Pipeline and Hazardous Materials Safety Administration SEP 1 2 2019

Reference No. 19-0025

This letter is in response to your March 4, 2019, email requesting clarification of the Hazardous Materials Regulations (HMR; 49 CFR Parts 171-180) applicable to the transportation of propane in a Specification MC331 cargo tank motor vehicle (bobtail). You describe a scenario where for propane deliveries made to customers, the driver must back into unfamiliar locations to complete the delivery and there are safety implications due to limited visibility and blind spots. As such, you are considering mounting a reel to the front of the bobtail chassis, which during transportation, will contain a residue of less than 10 gallons of propane in the piping and hose. Furthermore, you state that due to chassis variations or lack of chassis structure at the front of the bobtail chassis, you want to avoid installing a protection device.

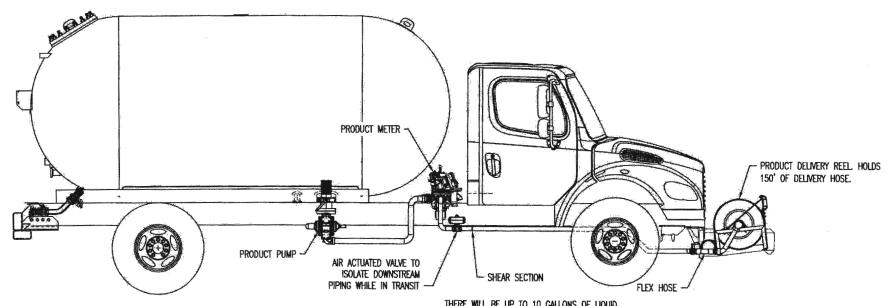
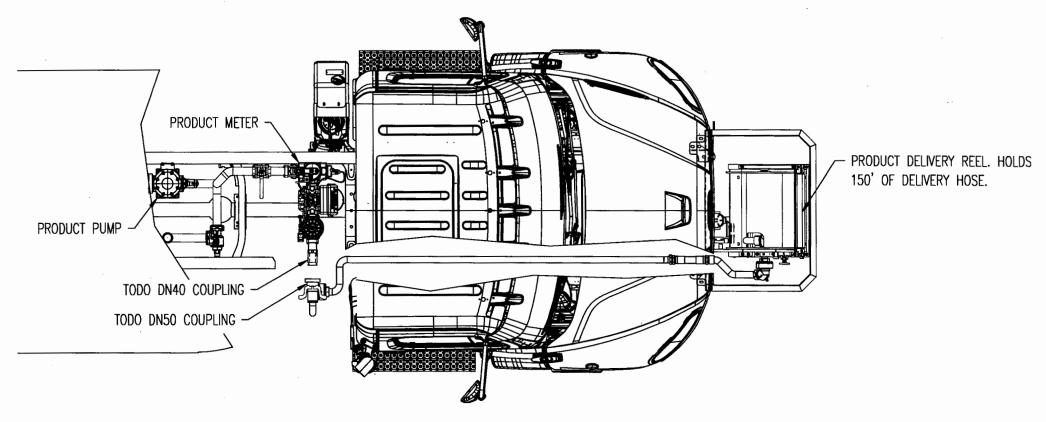
You ask whether your configuration of piping, the internal valve, a secondary valve, and shear section is enough isolation from the cargo tank to consider the approximate 10 gallons of residual propane in the reel and piping to be independent from the bulk package (e.g., separate packaging).

13' OF 1.5 PIPING = 1.37 GALLONS 150' OF 1" HOSE = 6.12 GALLONS PRODUCT IN REEL = 1 GALLONS

THERE WILL BE UP TO 10 CALLONS OF LIQUID
PETROLEUM DOWN STREAM OF THE ISOLATION VALVE IN
THE PIPING AND DELIVERY HOSE

THERE WILL BE UP TO 10 GALLONS OF LIQUID PETROLEUM DOWN STREAM OF THE DRY BREAK COUPLER IN THE PIPING AND DELIVERY HOSE

The answer is no. Although the hose and piping used for loading and unloading a Specification MC 331 cargo tank is subject to the packaging specification, the hose and piping are not authorized to contain hazardous materials during transport. The propane in the hose and piping must be removed to the fullest extent practicable upon completion of loading or unloading the cargo tank.

Furthermore, although there is no restriction against mounting the hose reel and piping to the front of the MC 331 chassis, in accordance with § 178.337-10(a), all valves, fittings, pressure relief devices, and other accessories to the cargo tank must be protected against damage caused by collision with other vehicles or objects. Moreover, in accordance with § 178.337-10(f)(2), each internal self-closing stop valve, excess flow valve, and check valve must be protected by a

shear section or other sacrificial device and the sacrificial device must be located in the piping system outboard of the stop valve <u>and</u> within the accident damage protection device to prevent any accidental loss of lading. Based on the information and attachments provided, your design would not meet the accident damage protection requirements prescribed in § 178.337-10.
